## **951 GOVERNMENT STREET SUBDIVISION**

APPLICATION NUMBER 15 DATE February 7, 2013  
 APPLICANT 951 Government Street Subdivision  
 REQUEST Subdivision

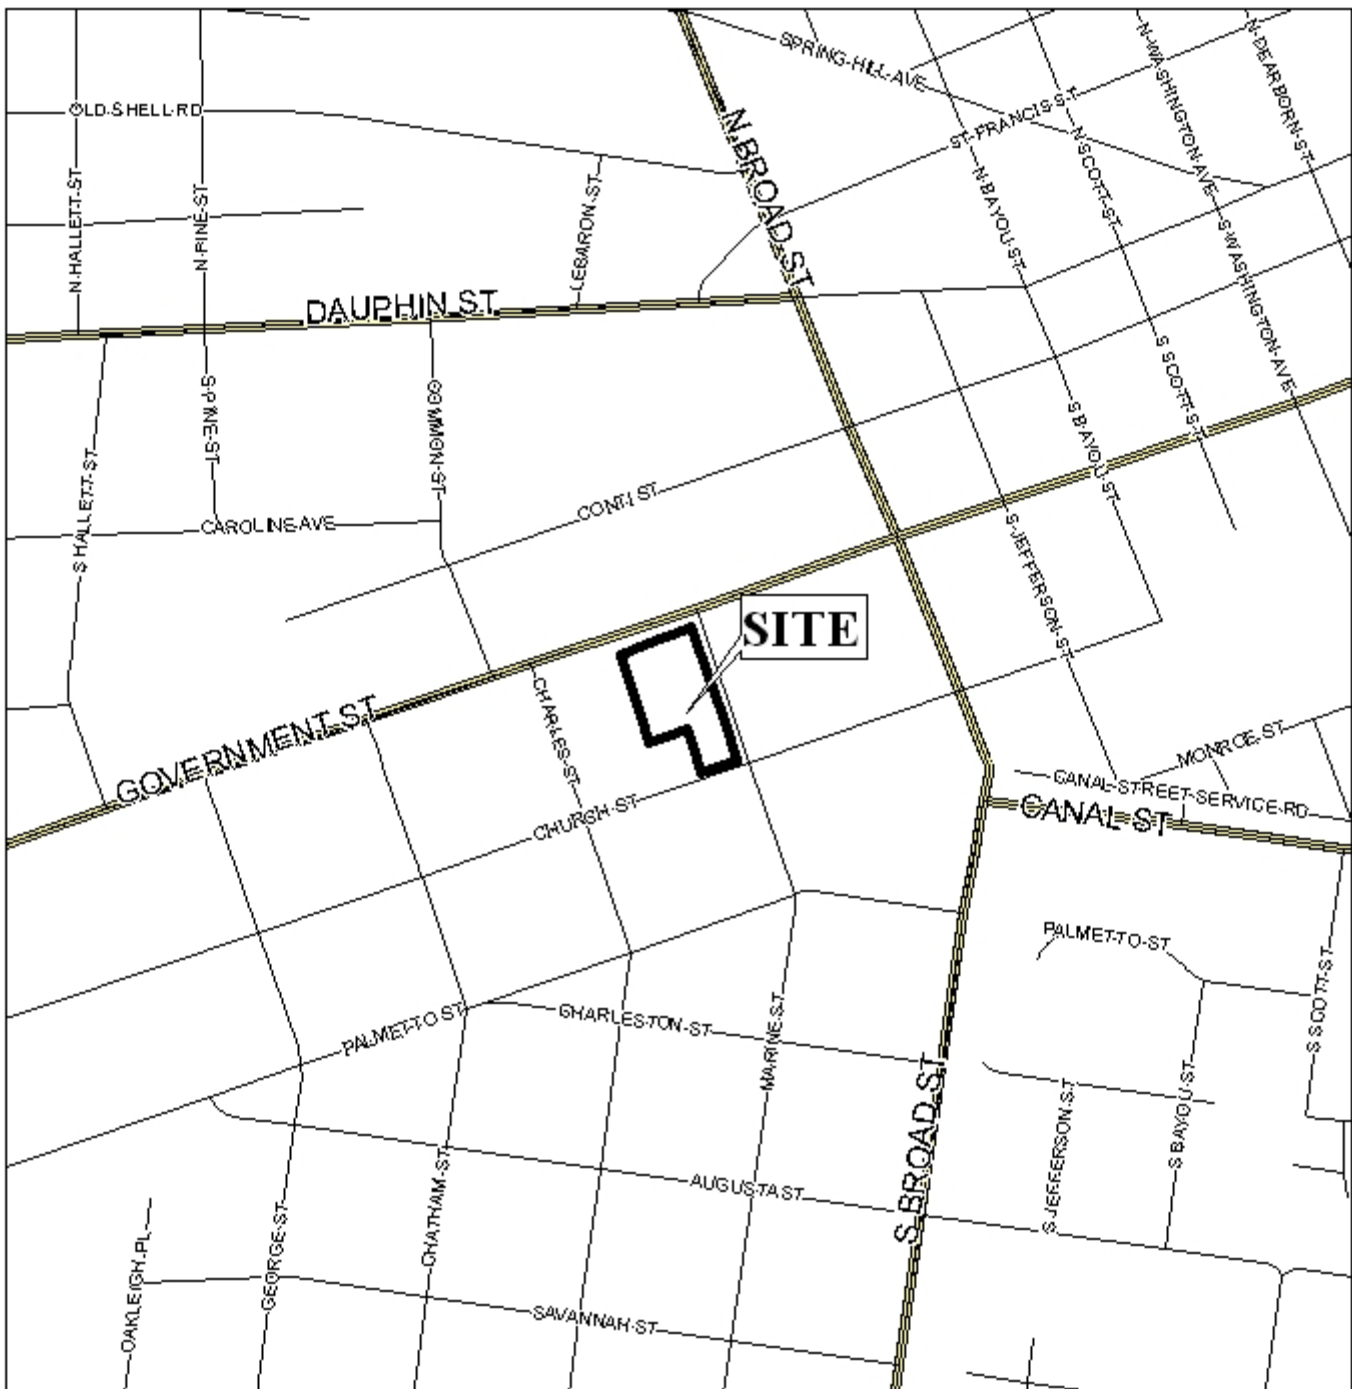
Access management is a concern due to the site abutting Government Street, an ALDOT controlled facility due to the presence of US Highway 90. The preliminary plat depicts two curb-cuts onto Government Street and one onto Marine Street. No curb-cuts are depicted onto Church Street. The curb-cuts depicted along Government Street are depicted as one-way in and one-way out, while the curb-cut onto Marine Street is depicted as a two-way curb-cut. The site has existing curb-cuts onto Government and Marine Streets, however, the plat indicates that all but one curb-cut on Marine Street will be closed. Existing large live oak trees along Government Street will require Urban Forestry review should any changes be proposed to the curb-cuts along

Government Street. The site should be limited to the two one-way in and one-way out curb-cuts onto Government Street and one two-way curb-cut onto Marine Street, with access to Church Street denied, with the size, design and location subject to Traffic Engineering, Urban Forestry, and ALDOT approval, as appropriate, and with modified or new curb-cuts complying with AASHTO standards. Any unused curb-cuts should be removed and landscaped with sod, with appropriate right-of-way permits.

The preliminary plat depicts the 25-foot minimum building setback line, required by Section V.D.9. of the Subdivision Regulations. The setback line should be depicted on the final plat, if approved.

The preliminary plat depicts a corner radius where Marine Street intersects both Government Street and Church Street. Any corner radius must comply with Section V.D.6. of the Subdivision Regulations.

- 1) Placement of a note on the plat stating that the site is limited to one in and one out curb-cut onto Government Street, and one two-way curb-cut to Marine Street, with the size, design and location to be approved by Urban Forestry, Traffic Engineering and ALDOT, and to comply with AASHTO standards;

- 2) Placement of a note on the plat stating that the site is denied access to Church Street;
- 3) Removal and sodding of unused curb-cuts along Marine Street, with the appropriate right-of-way permits;

- 4) Depiction of the 25-minimum building setback;
- 5) Dedication of a corner radius at each street intersection, in compliance with Section V.D.6. of the Subdivision Regulations;
